CORRIGENDUM/ADDENDUM

Tender No. NAL/PUR/CAD/315/20-Z

In continuation of CSIR-National Aerospace Laboratories Tender No. NAL/PUR/CAD/315/20-Z Dated 10-Dec-2020 and Pre-Bid Proceedings hosted on 29-Dec-2020 for **"To Carry Out the Design and Execution of Complete Interiors and External Painting - SARAS Fuselage Assembly into SARAS mk2 Cockpit Etc."**, kindly note the changes as appended below.

QUERIS RAISED BY BIDDERS AFTER VISIT TO CSIR-NAL FACILITY ON 5 – 6 JAN 2021

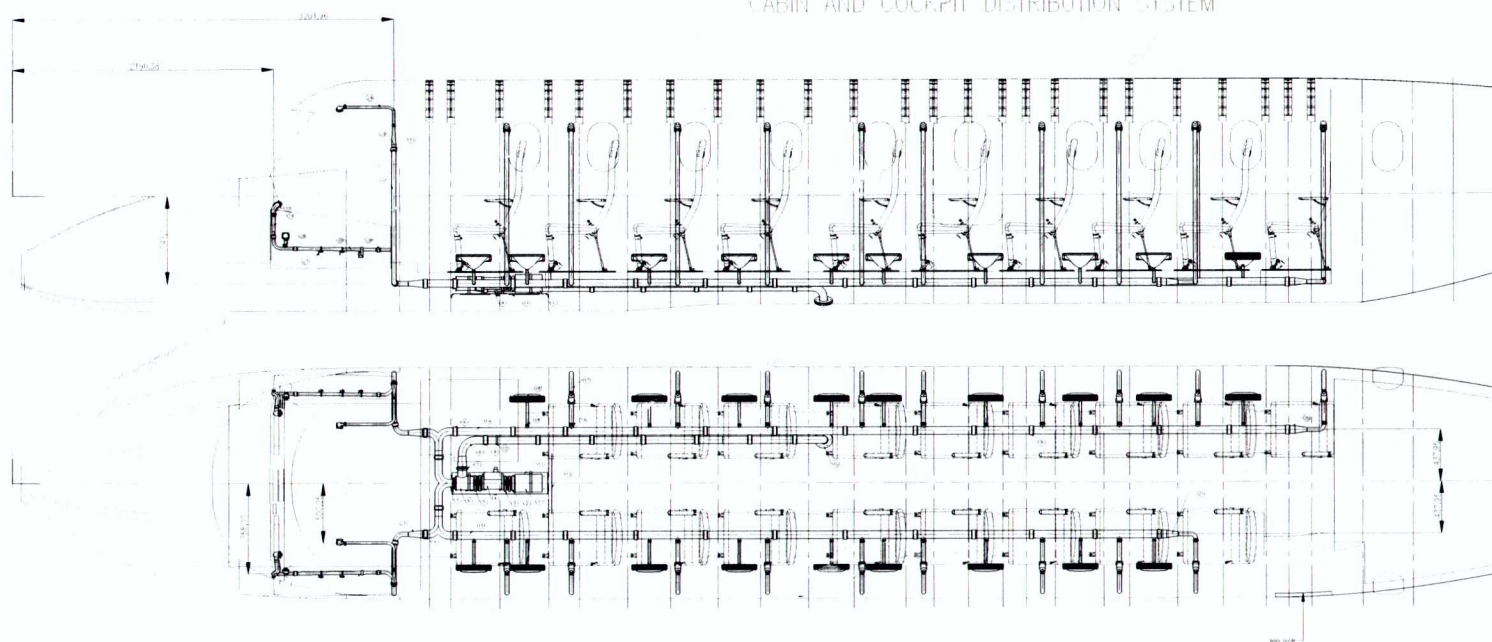
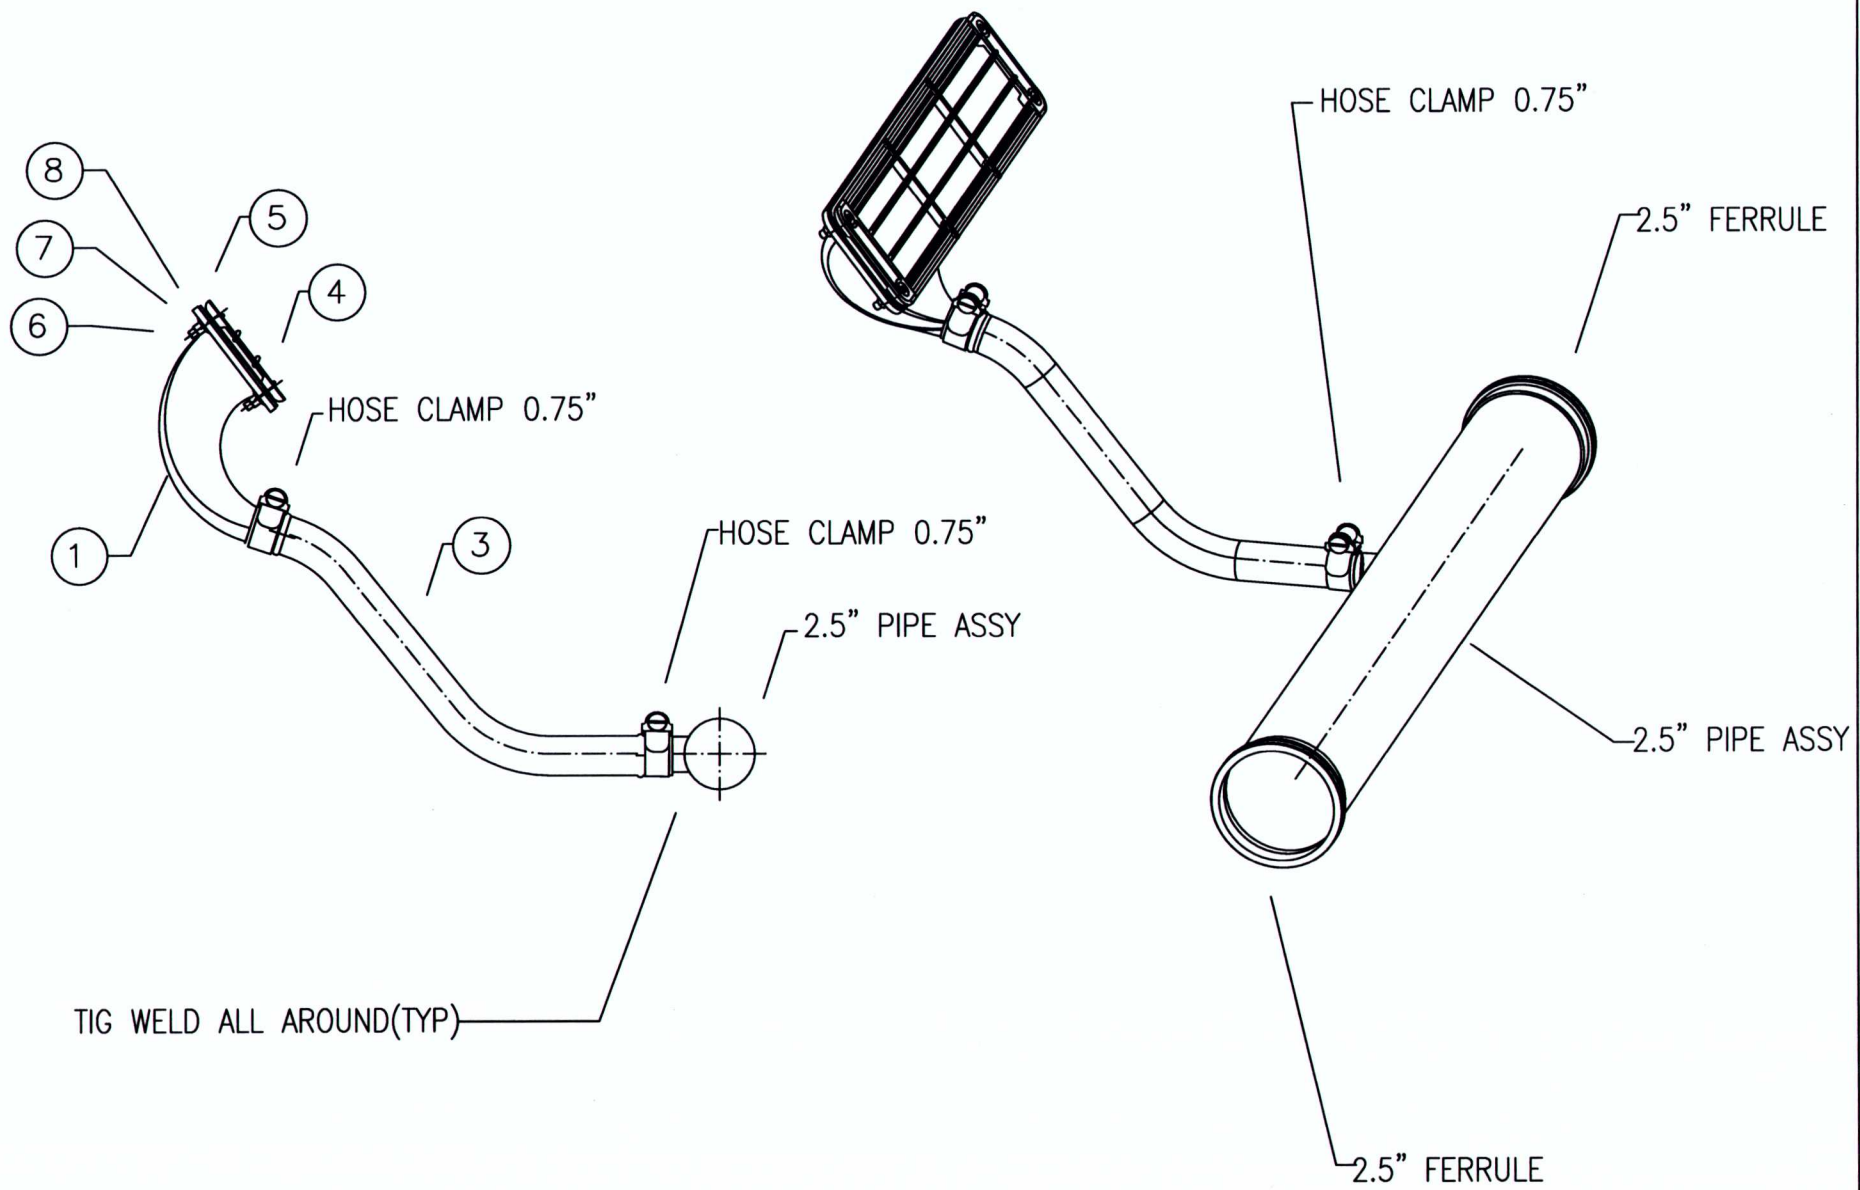
10	Lavatory Module location	Can we change the location of lavatory module?	Lavatory Module location is fixed as per the layout behind the Cockpit Partition Wall on RH side.
11	L1 Entry Door	Is the doors location fixed, as per drawing given in tender document?	Locations of Main Door and Emergency Doors are as in the Fuselage Component available at Golden Jubilee Aircraft Hangar. Location of the Cargo Door is yet to be finalized. CSIR-NAL will provide the required cut-out for the Cargo Door and also the door panel will be provided by CSIR-NAL. Vendor is required to provide on the interior side of the door panel, thermo-acoustic blanketing and suitable paneling similar to the Wall Paneling.
12	Safety and emergency Equipment	Does vendor need to make provision for storage of Safety and emergency equipment? If yes, Please confirm locations.	Vendor shall make provisions for storage of Safety and Emergency Equipment. These equipment will be provided by CSIR-NAL. Plan view showing the locations of these equipment shown in ANNEXURE, Pg-5 & 6
